Service Bulletin

Date: August 2015

Brands: Husqvarna, Poulan Pro, Jonsered, Parton, McCulloch

Product: 2014 Dual Stage Snow Throwers

Opening Carton:

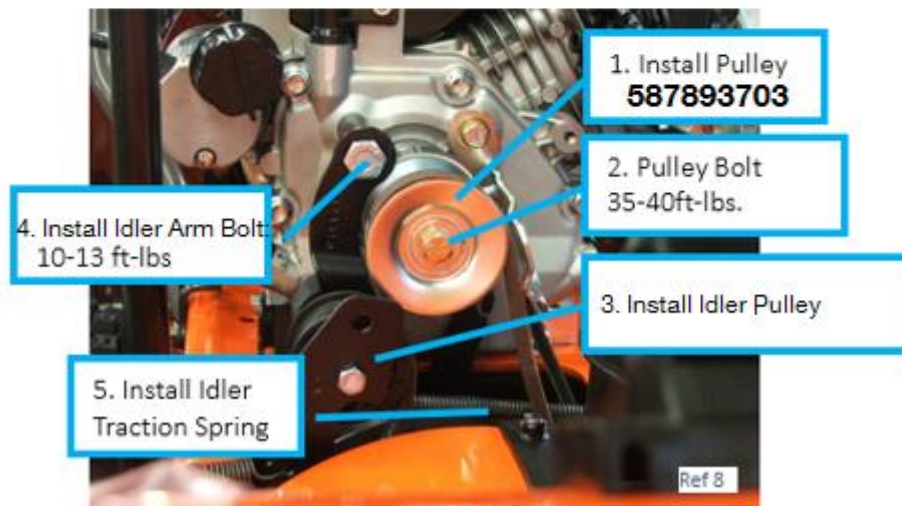
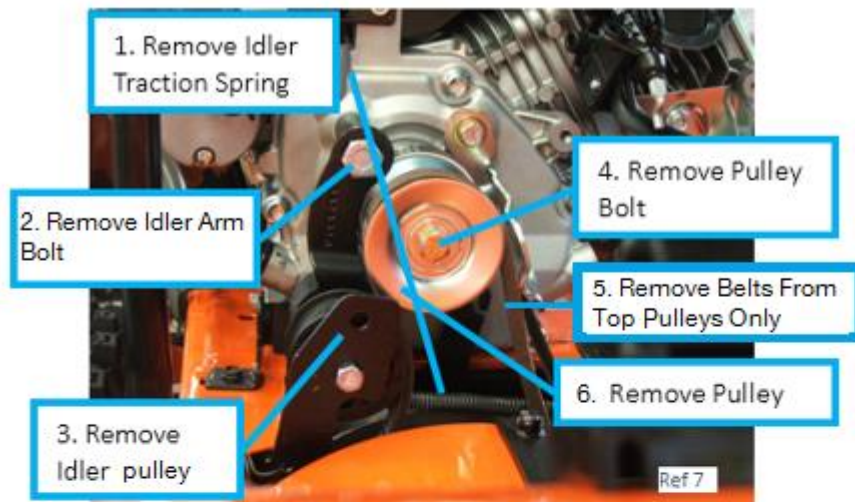
Open the top flaps to access the snow thrower (Ref 1). Unit can be accessed after folding back the two top flaps, and the "front" marked flap (Ref 2, 3). Pulley cover will need to be removed to access pulleys. Remove the two screws holding the pulley cover as indicated by green arrows (ref 4, 5). Pulley cover can be lifted off for access to pulleys to complete rework (ref 6)

5. Check belt tension

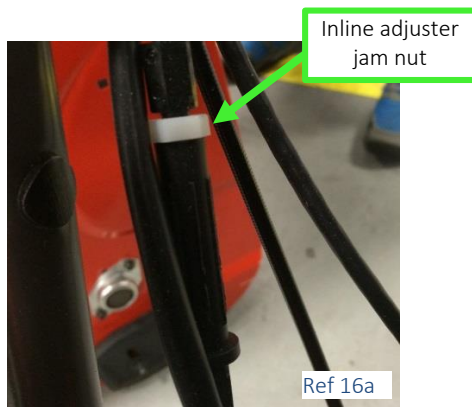
To check belt tension, verify there is no slack in the cable with auger control disengaged. The cable must have all free travel removed but not stretch the spring. (Ref. 15a and 15b)

Adjust cable tension with inline adjuster located on the right side of operator control handle. Loosen white jam nut of cable inline adjuster. Hold one side of the adjuster while turning the other side. This lengthens or shortens the cable. Adjust until cable tension is correct (Figs. 16a and 16b). Tighten jam nut.
